# EAST TOWN CROSSING

## COMMERCIAL LOT 1 - SUITE 2 T.I.

City of Puyallup  
Planning  
Division  
APPROVED

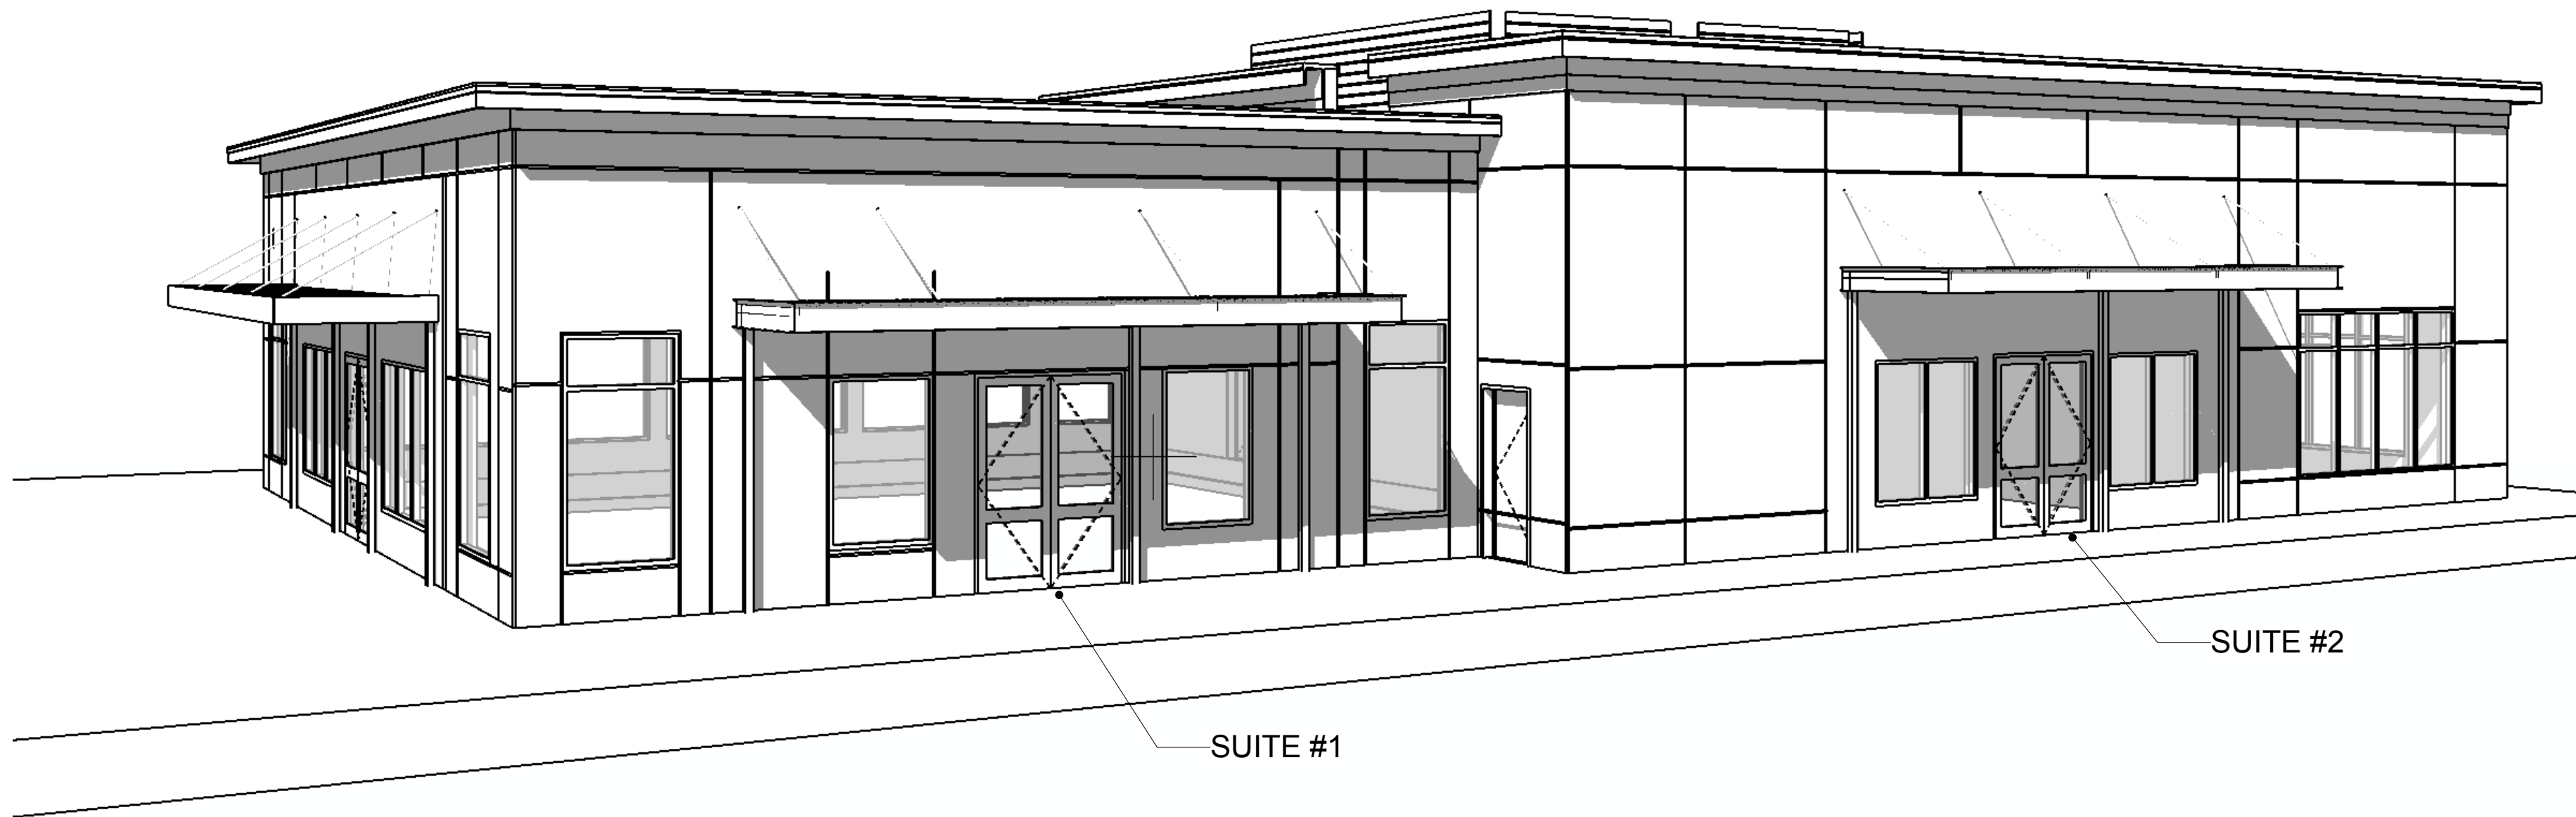
Since sheet AG1.0 SITE PLAN, was not included in the construction plan set, provide the minimum site information including address (727 SHAW RD, Unit B, PUYALLUP, WA 98372) and tax parcel number (APN 0420264071) on sheet AG1.1 COVER SHEET.

AG1.2

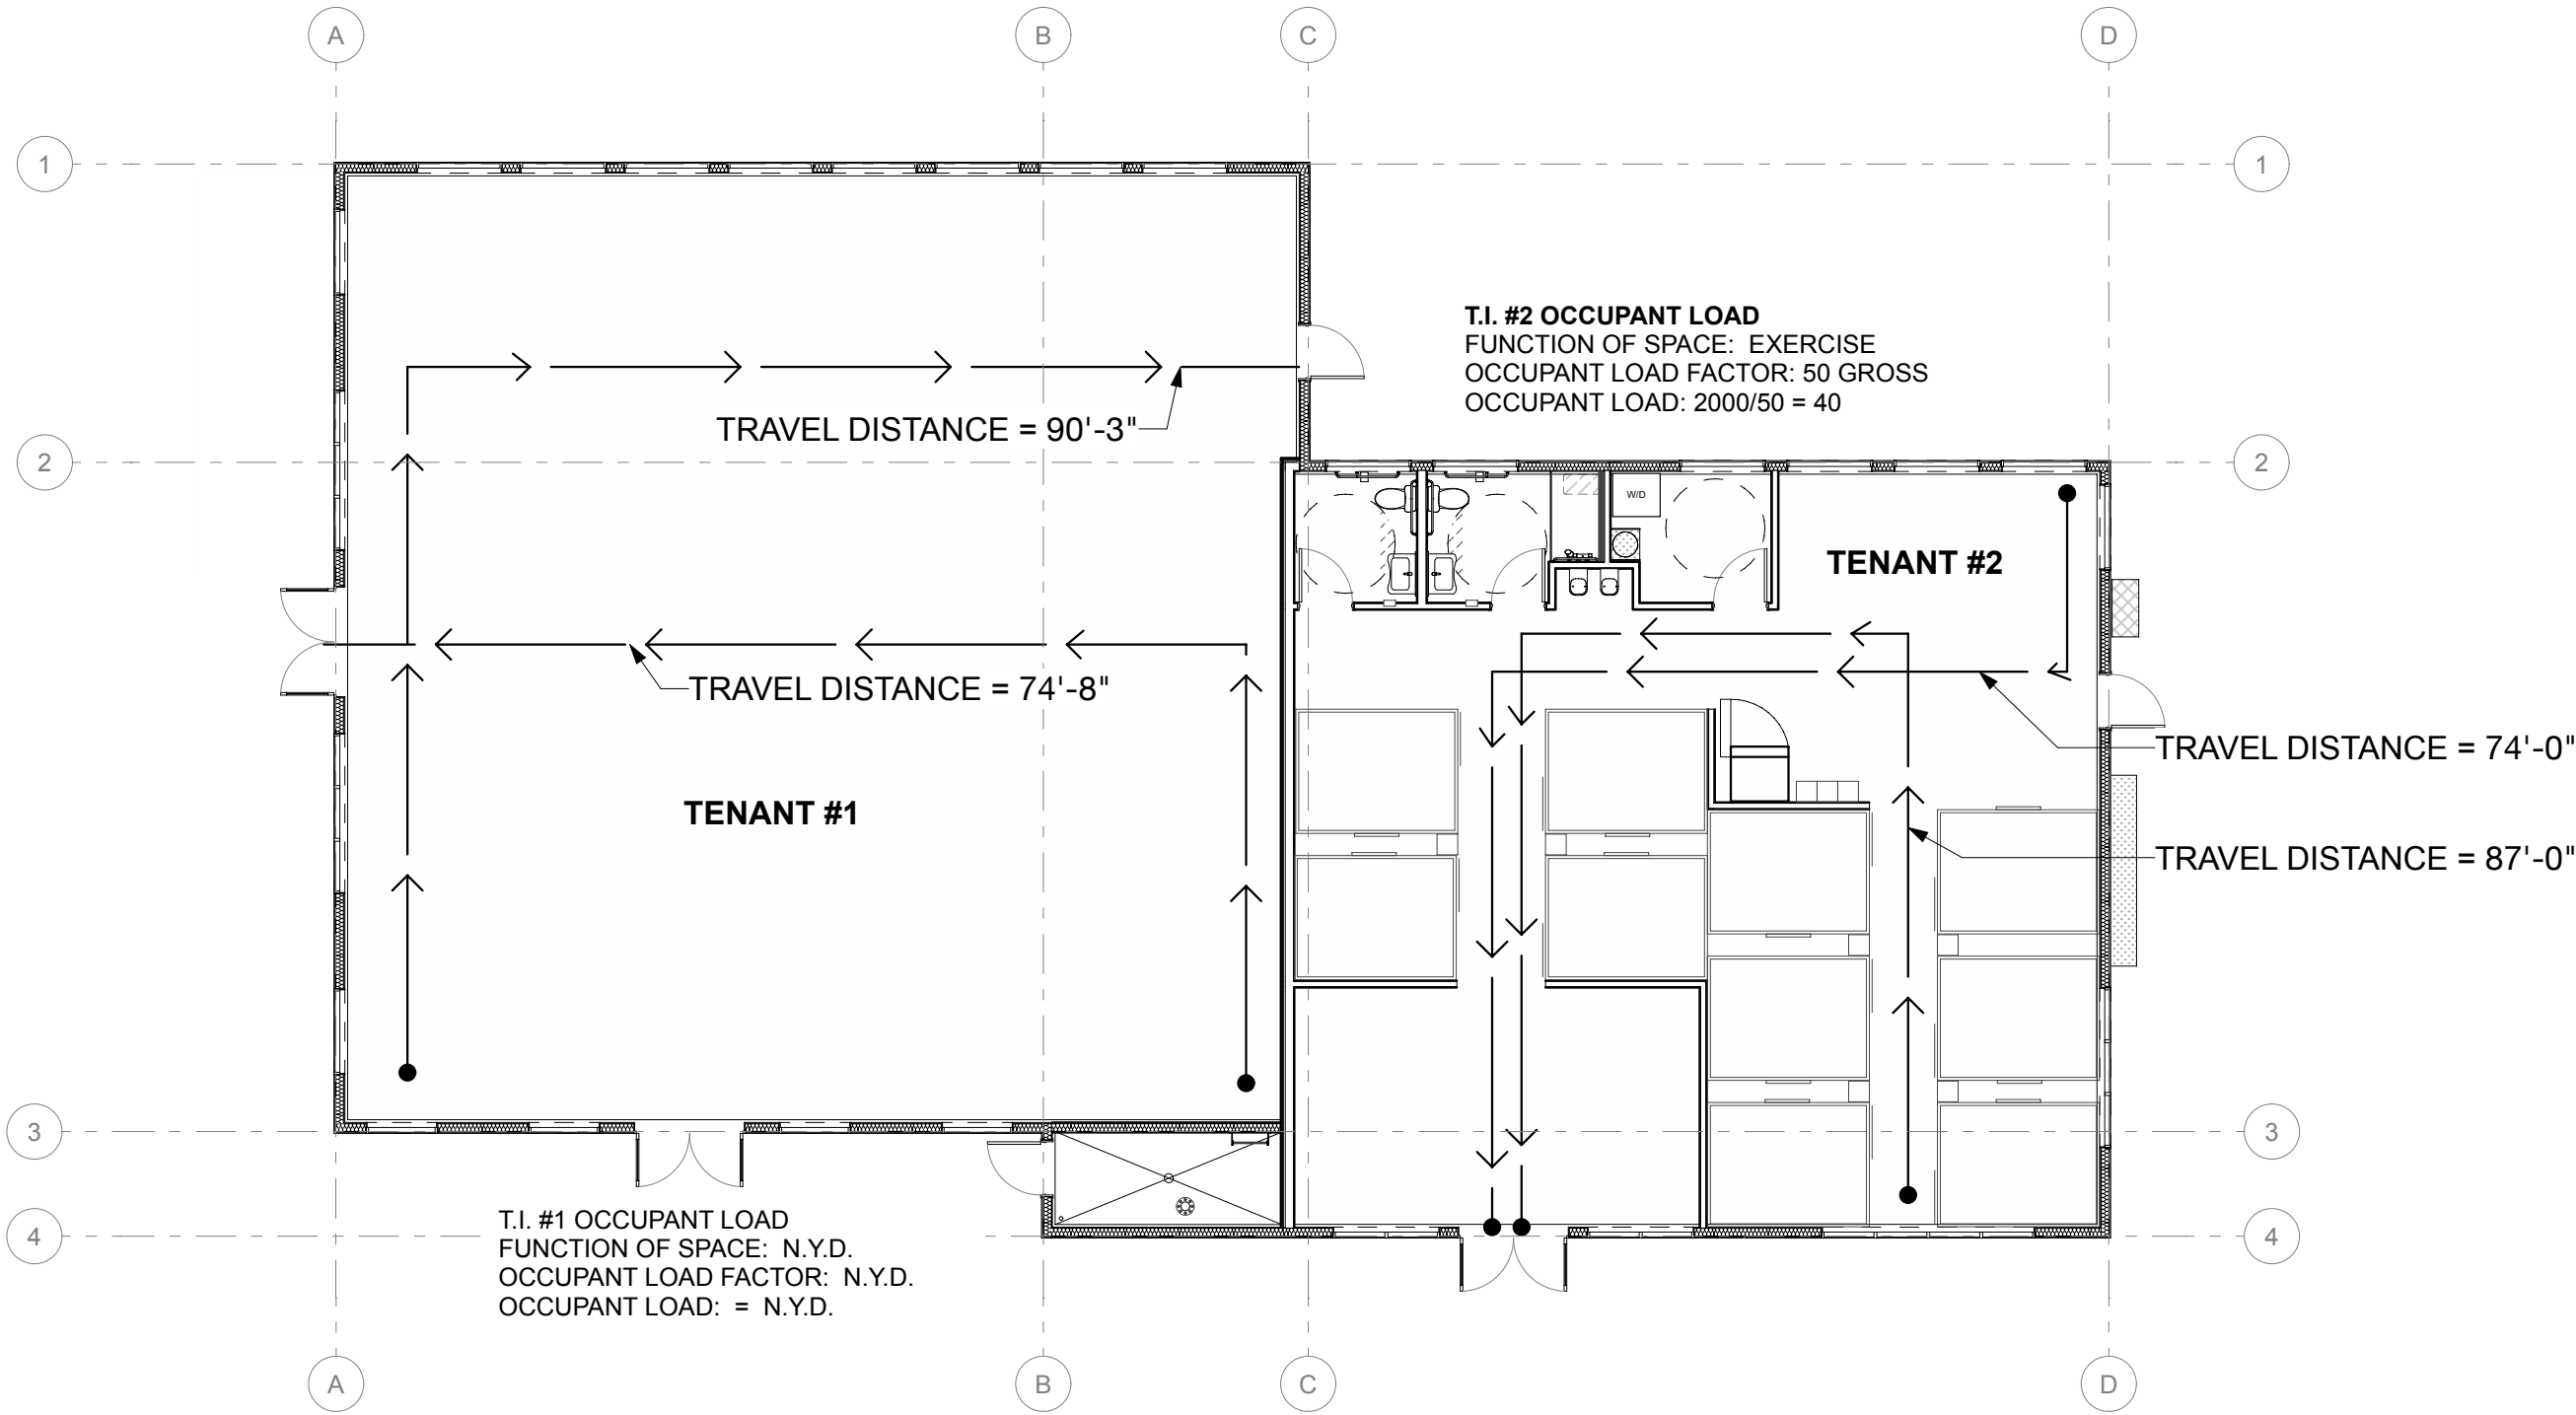
Remove information that is not applicable to the tenant space.

SHEET TITLE:  
LOT 1 - FLOOR 1  
SUPPLY PLAN

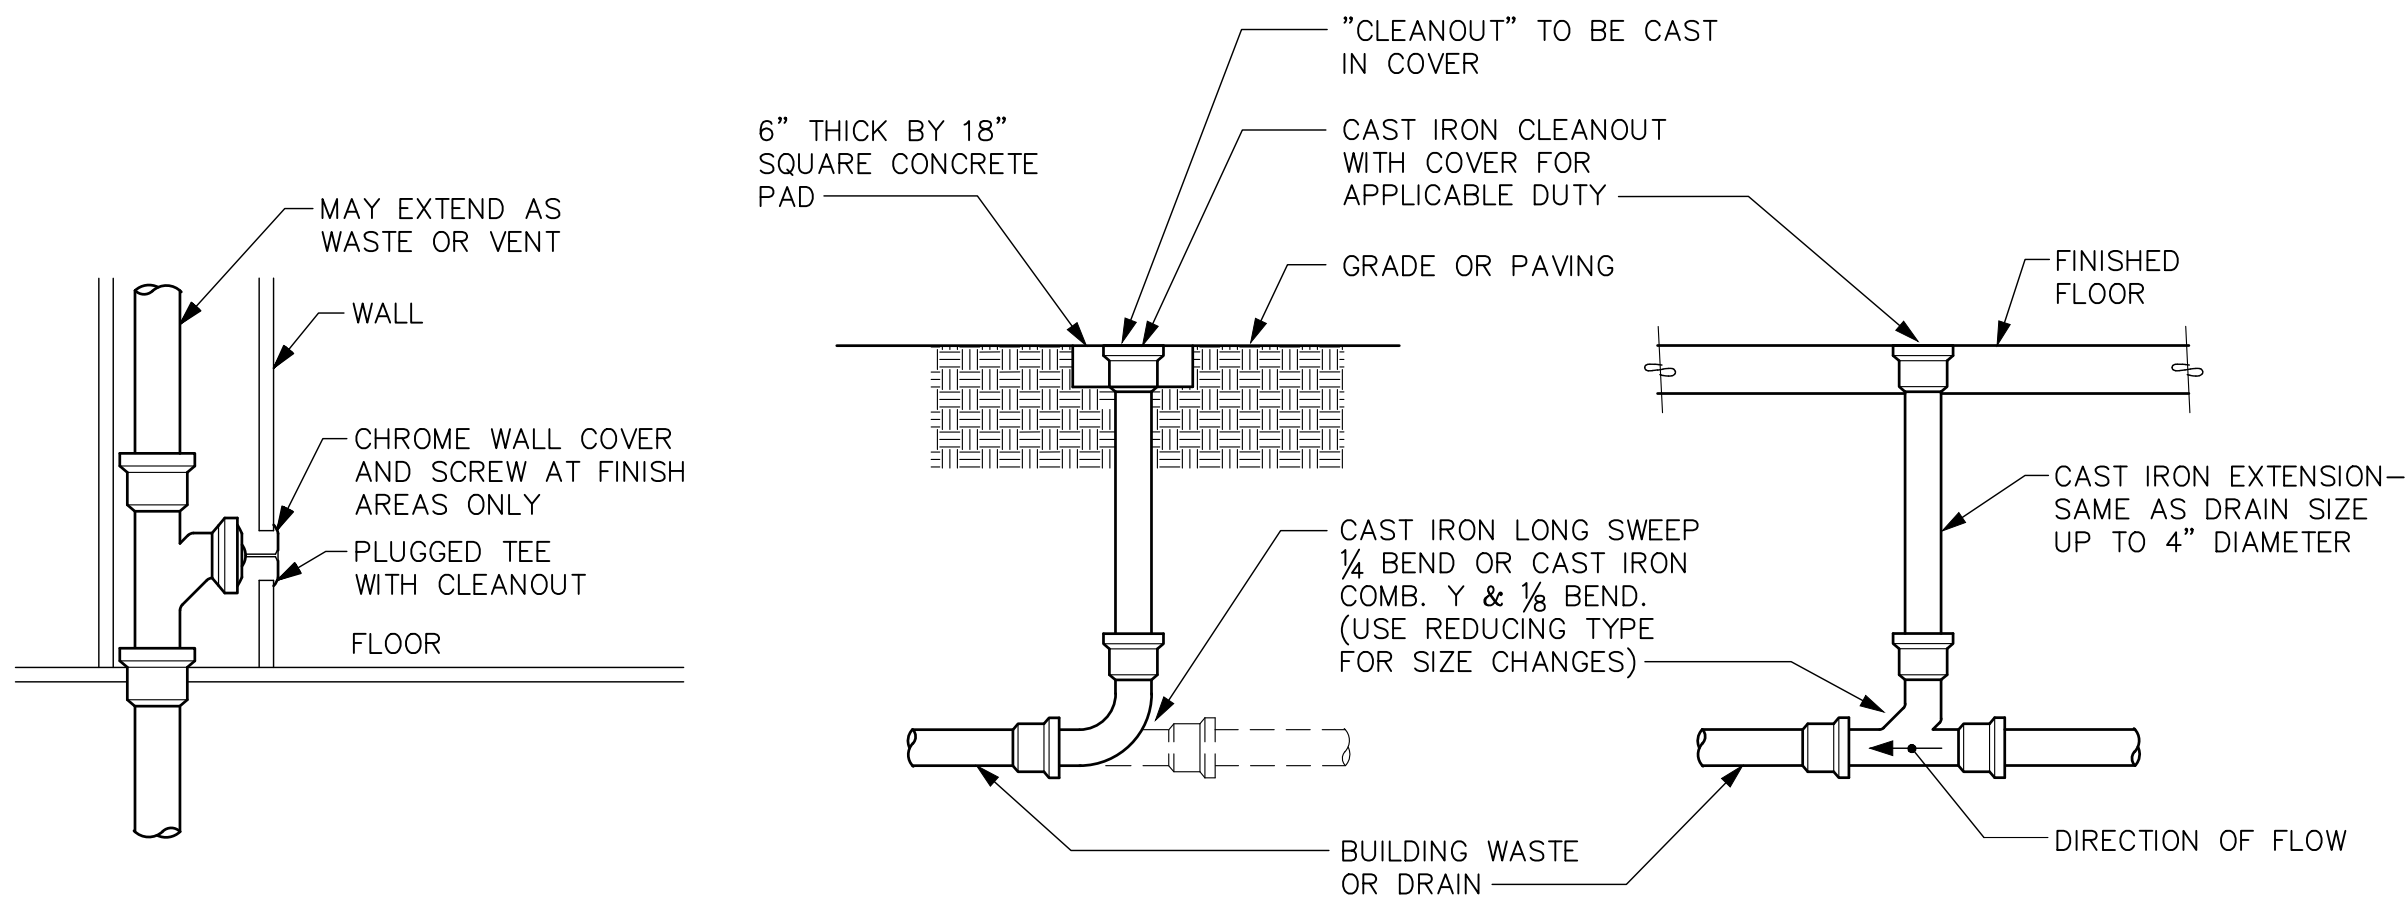
Correct and label domestic water supply location. Refer to building permit PRNC20250094 and civil permit PRCCP20230970.
